Starlight Sweaters Ltd.

National University, Gazipur, Sadar
(23.97906N, 90.37702E)

19 March 2014

Observations

Column Impact Loading

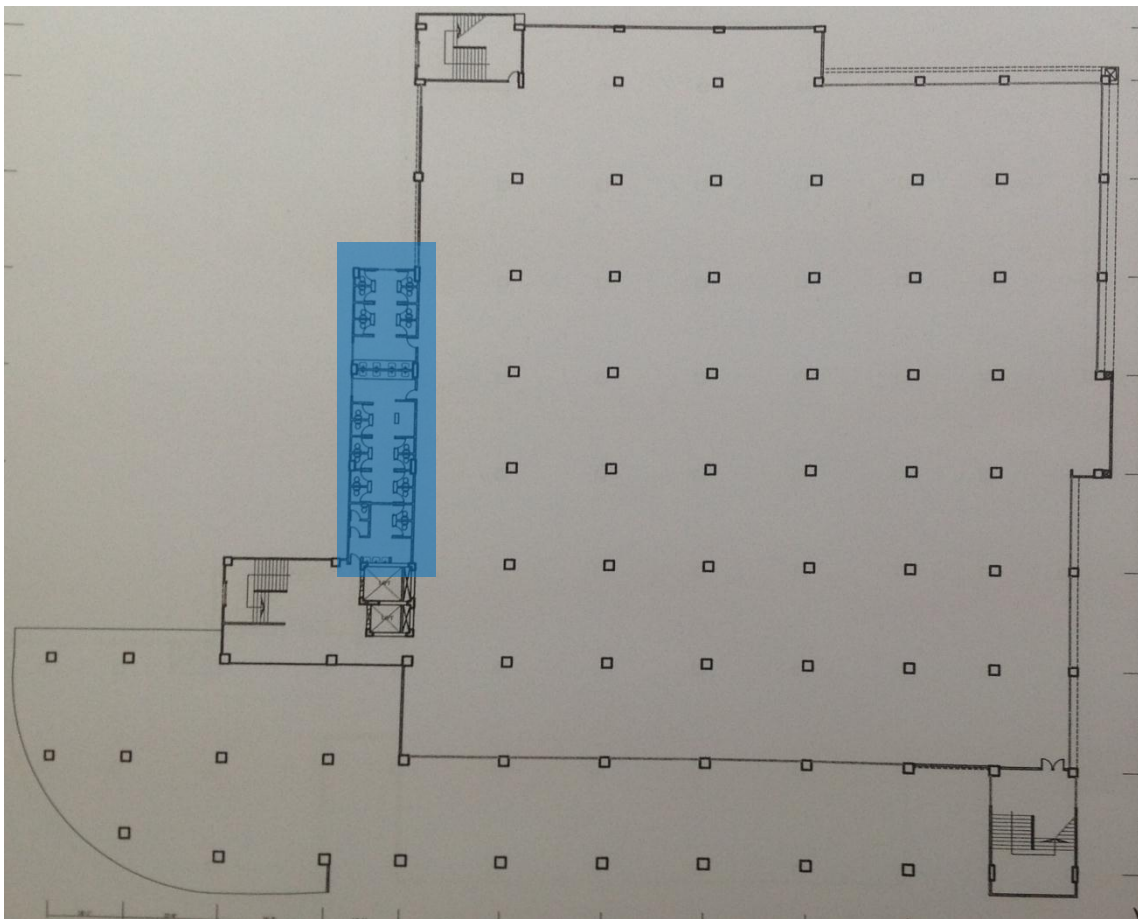
**Columns at the south of the building
adjacent to the entrances are in danger of
being accidentally hit by vehicles entering/
leaving the facility**

16 No columns in delivery area at risk of being struck by vehicle.

Building Engineer to check that the columns have been adequately designed for impact loading. Adequate protection to be provided to columns at risk of damage due to impact loading.

Columns strength

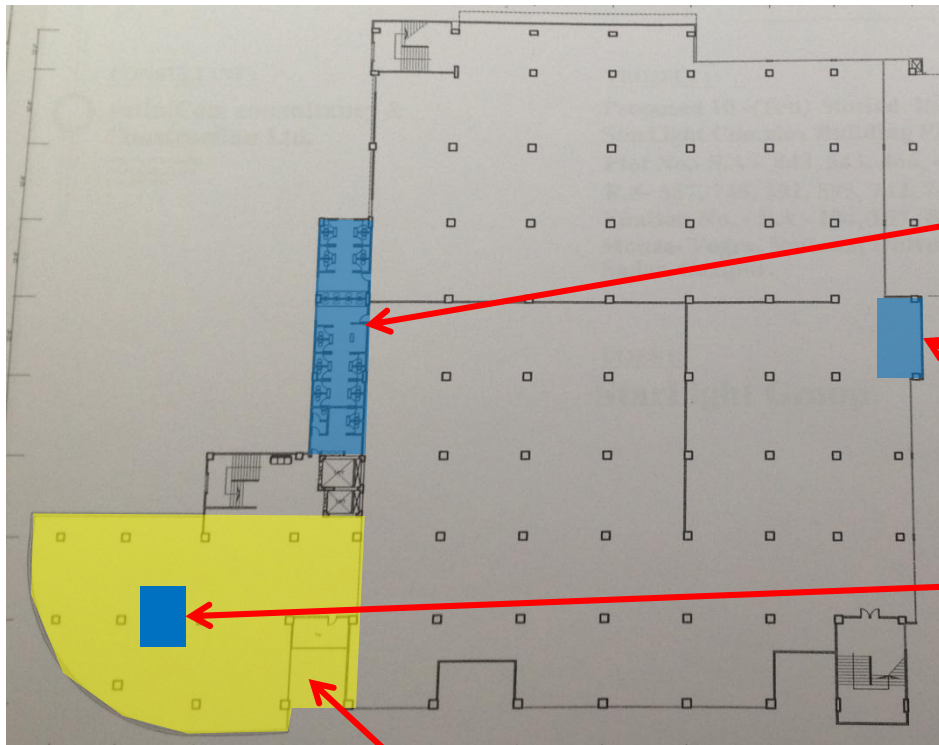
Columns below storage areas and water tanks appear to be stressed in excess of normal design limits – Building Engineer to verify concrete stresses and in-situ concrete strength

Cursory calculations indicate that the working stresses of columns in the area of the concrete water tank are in excess of normal design limits

Building Engineer to check that columns in the area highlighted have been designed to accommodate loads.

Water Tank Loads / Load Management

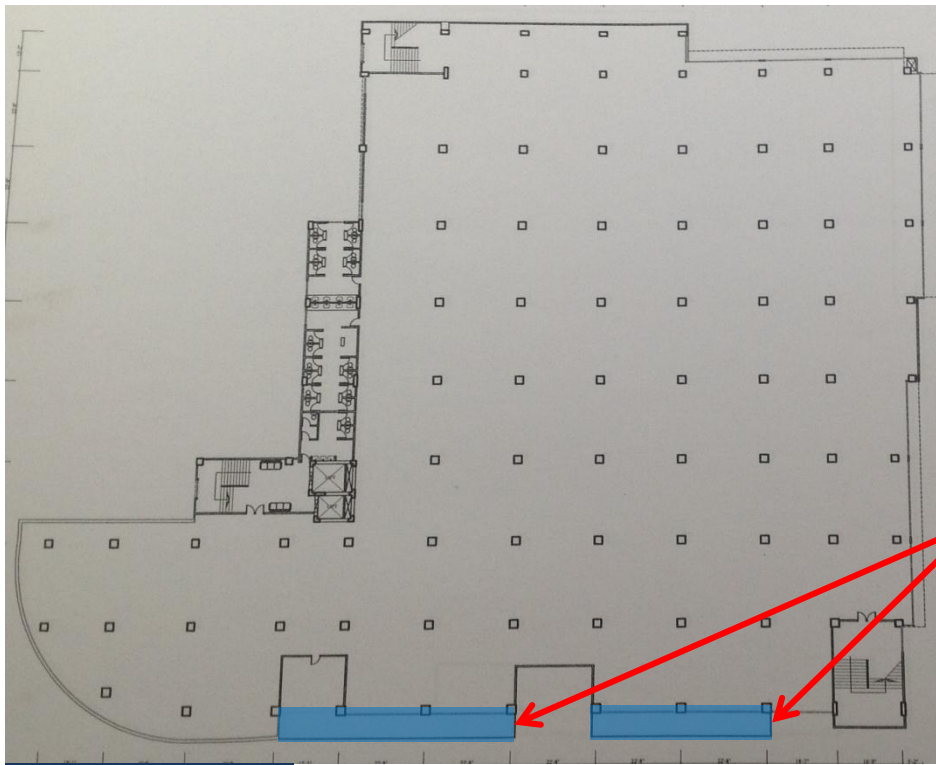
Design Check required for the loading from the water tanks (plastic and concrete) at roof level and for areas of observed high floor loading as indicated

2nd & 5th to 7th Floor – Storage Area

- 1 no. concrete and 7 no. plastic water tanks located on roof slab.
- Building Engineer to check that the slab and beams have been adequately designed to carry loads due to concrete and plastic water tanks.

Building Engineer to prepare controlled loading plans for all floors, which will designate where storage can be placed.
